Reference: P190302

**RE: P190302 - DUBLIN, Oldcourt Ph 7 – Request for Additional Information relating to Reg. Ref. SD22A0356**

**Figure 1 Access points**

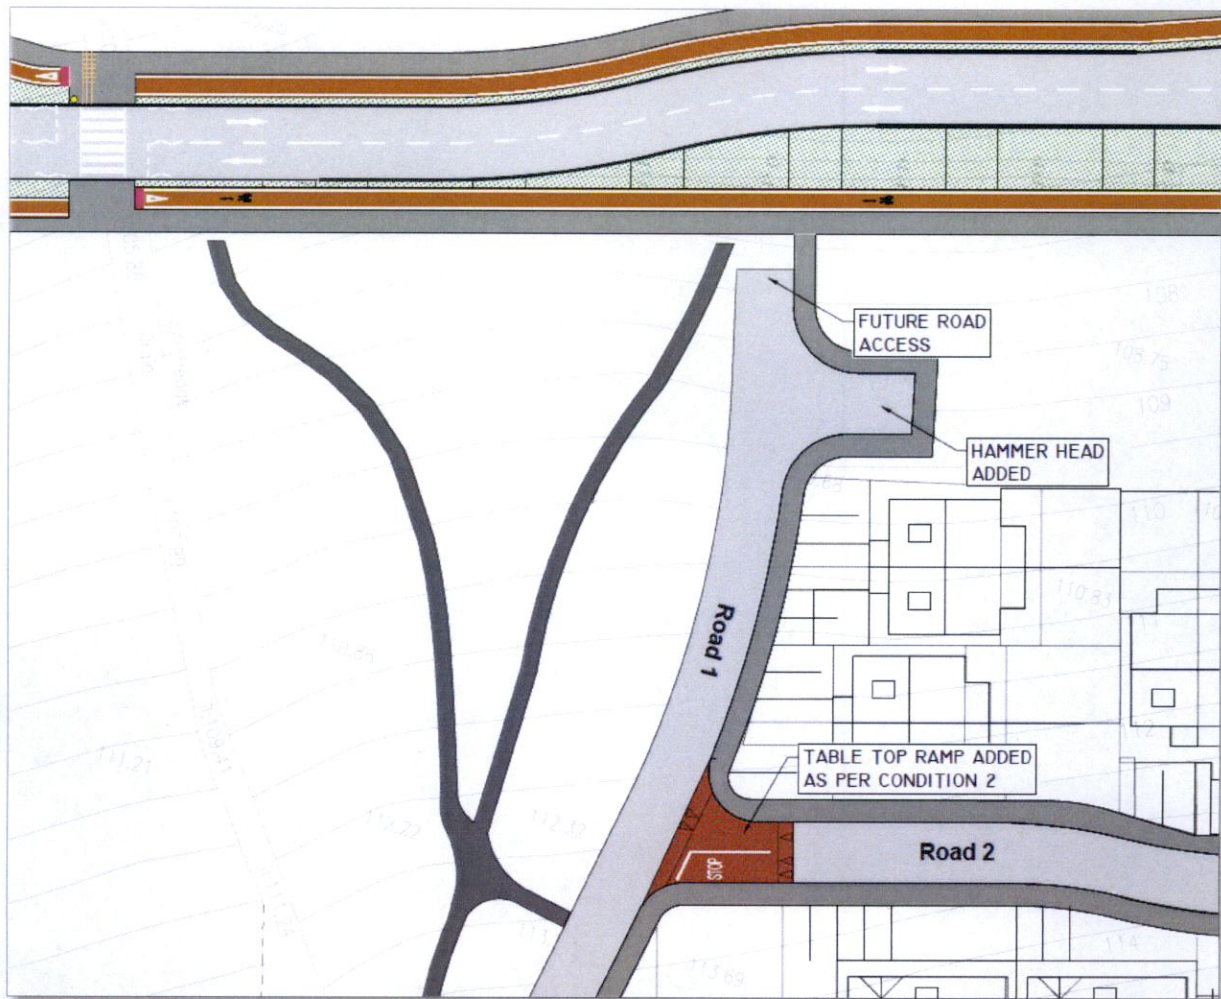
1. *The applicant shall submit a revised layout of not less than 1:200 scale which shows a formal twoway cycle and pedestrian connection that connects with the main link street and is designed in line with the Nation Cycle Manual standards.*

Under SD17A/0468, pedestrian and cyclist connections were provided to the Link Street via the 3 No. locations, as illustrated below.

The eastern access point was intended to be for pedestrian access only due to the level differences between the Link Street and Road 1 of the proposed development.

It was the intention of the permitted scheme that cyclists would use the internal estate road to gain access to the Link Street. From there, cyclists can use the dedicated cycle infrastructure to travel east or west along the new Link Street.

This was done on the basis that the Road 1, as illustrated above, was at a considerably higher level than the new Link Street resulting in difficulties achieving gradients that were compatible with the National Cycle Manual standards.
